Due to component issues at Honeywell our traditional horn/strobes (CM-7004) are temporarily unavailable.
CO2Meter has worked with Honeywell to temporarily provide us an alternate horn/strobe (CM-7004-2).

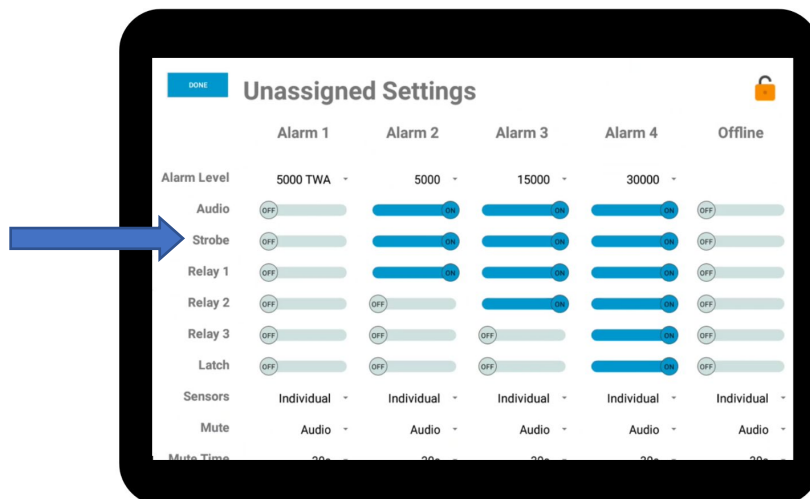
The differences with this temporary horn/strobe are:

- The horn and strobe alert together
- The "CO2" sticker will be black
- Detailed instructions about installation and precise settings will be provided

The "STROBE" switch on the tablet settings page controls the horn and strobe function on the CM-7004-2. This switch MUST be toggled to the "ON" position for the system to alarm properly.

If Alarm 1 settings are altered from the factory settings you must also toggle the "AUDIO" and "STROBE" on as well.
